STATE OF MAINE
DEPARTMENT OF TRANSPORTATION
16 STATE HOUSE STATION
AUGUSTA, MAINE 04333-0016

June 4, 2026
Subject: US Route 1 SB On Ramp
Bridge Wearing Surface
Replacement
WIN:029276.00, 029314.00
Location: Brunswick
Amendment No. 3

ESTIMATED QUANTITIES				STATE OF MAINE DEPARTMENT OF TRANSPORTATION Federal Project No. 2931400 WIN 029314.00				US 1 SB RAMP BRIDGE BRIDGE NO. 6286 CROSSING I-295 BRUNSWICK ESTIMATED QUANTITIES & GENERAL CONSTRUCTION NOTES				SHEET NUMBER

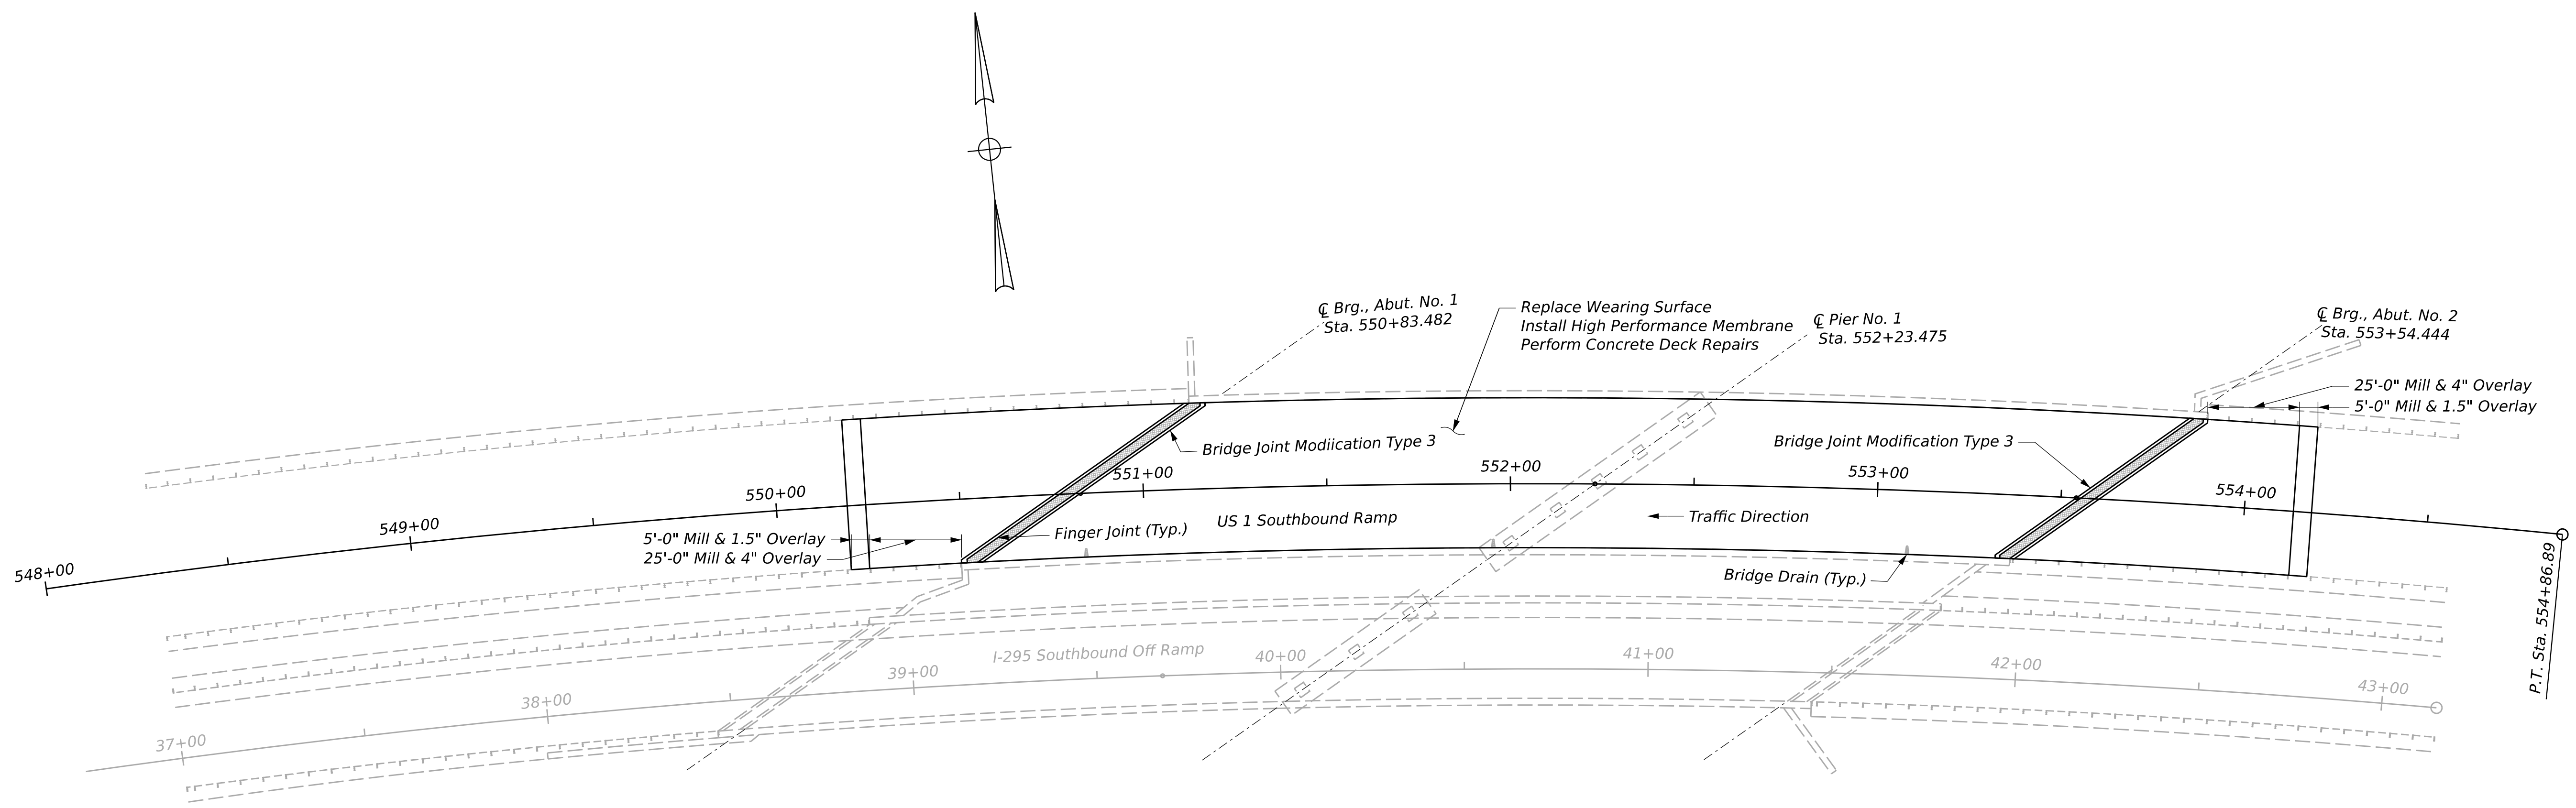
REMOVE Sheet Number 2 of 5, ESTIMATED QUANTITIES & GENERAL CONSTRUCTION NOTES and **REPLACE** with the attached Sheet Number 2 of 5, ESTIMATED QUANTITIES & GENERAL CONSTRUCTION NOTES, dated 6/3/26.

526.301	PORTABLE CONCRETE BARRIER, TYPE I (440 LF)	1	LS												
527.34	WORK ZONE CRASH CUSHIONS	2	UN	MPP				REMOVE ITEM 521.32							
627.744	6" WHITE OR YELLOW PAINTED PAVEMENT MARKING LINE	1200	LF

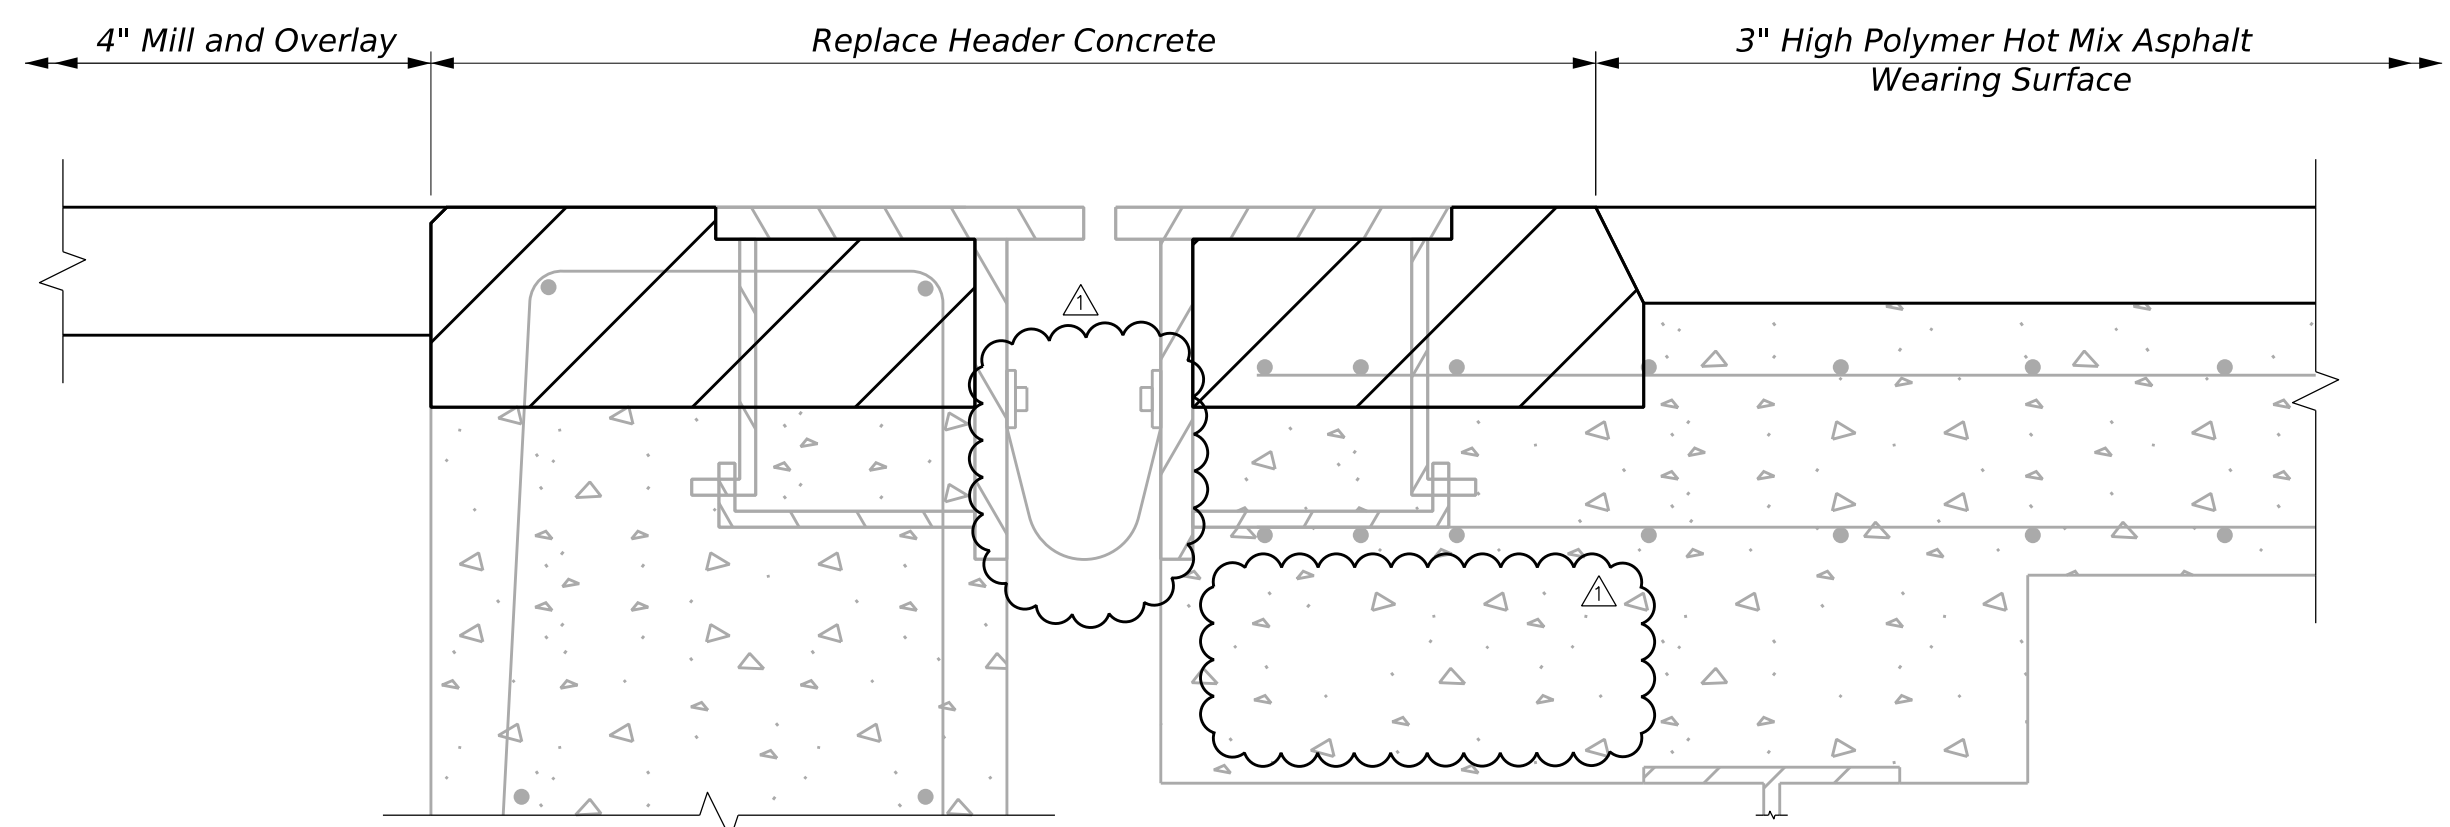
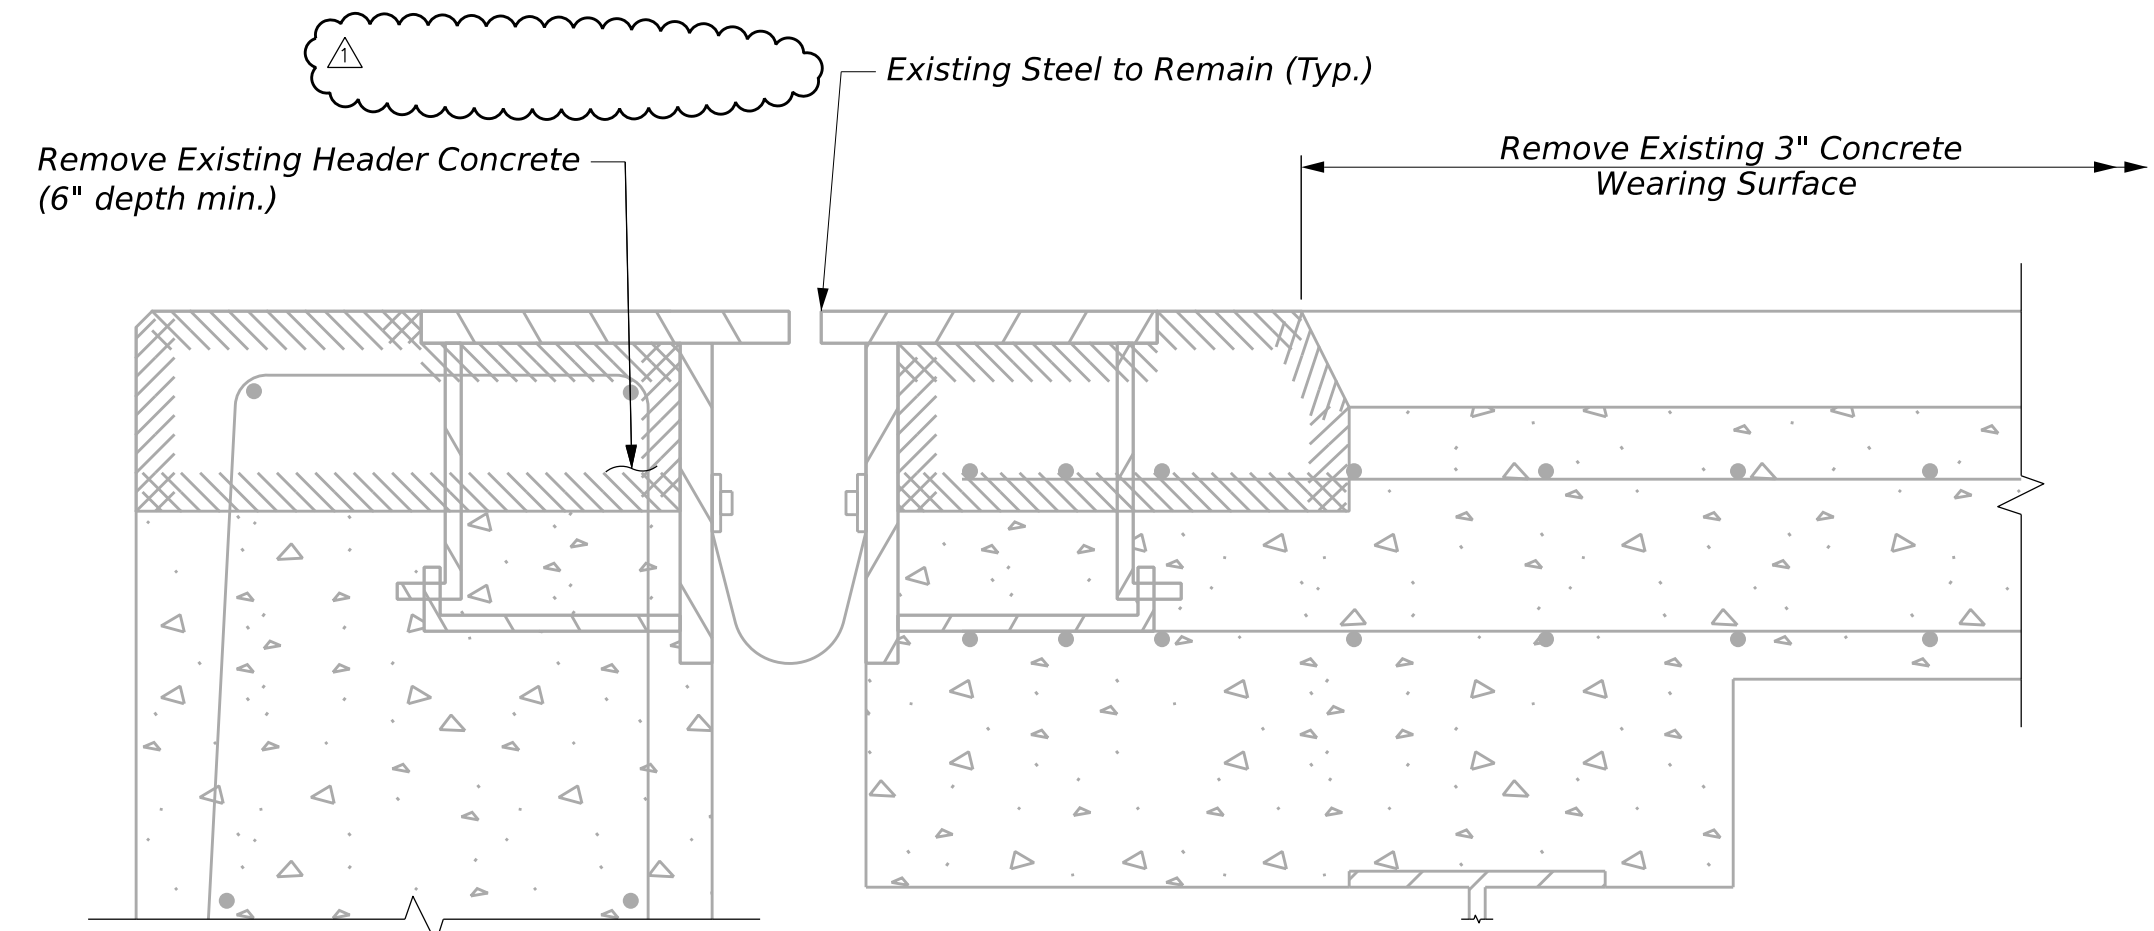
REMOVE Sheet Number 3 of 5, GENERAL PLAN and **REPLACE** with the attached Sheet Number 3 of 5, GENERAL PLAN, dated 6/3/26.

- JOINT MOD NOTES**
- Note 1 removed.
 - Remove header concrete to 1" below reinforcing steel, to sound concrete, and a minimum of 6", whichever is deeper.
 - Refer to the Standard Details for information not shown here.
